P 535966

**ON-SITE SEWAGE DISPOSAL SYSTEM  
 HOWARD COUNTY HEALTH DEPARTMENT  
 BUREAU OF ENVIRONMENTAL HEALTH**

ADDRESS: 11276 Old Frederick Road PROPERTY OWNER: Mogmano LLC.

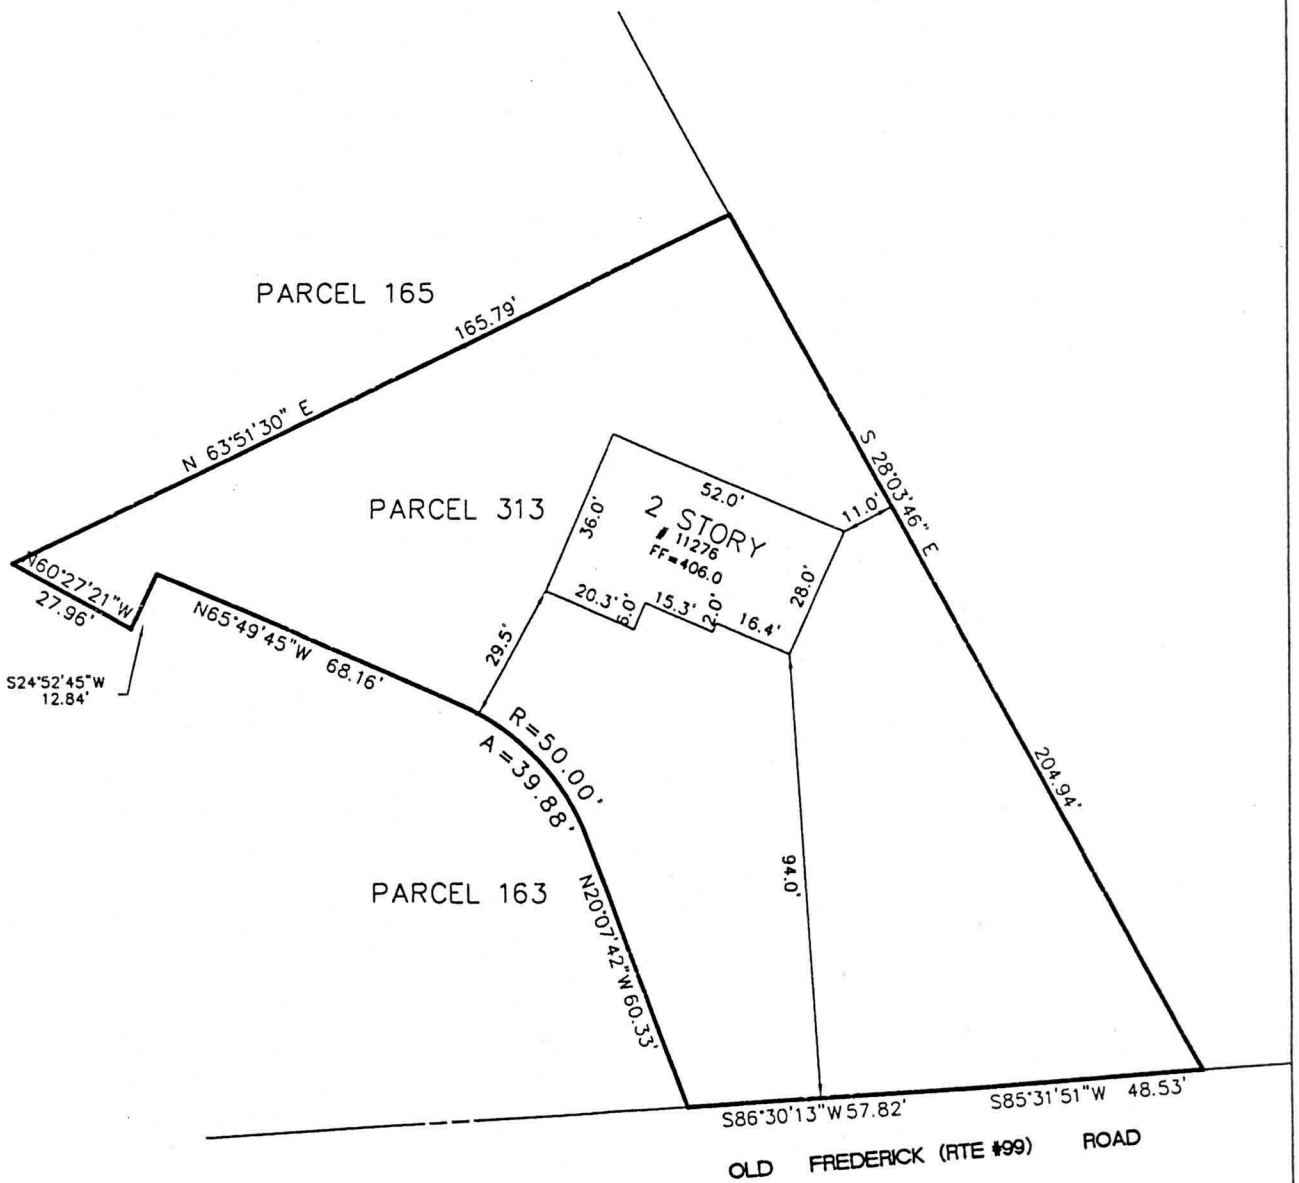
9/6/2011 Install one 75' trench across section of easement closest to road. Keep tank 20' from house. BB
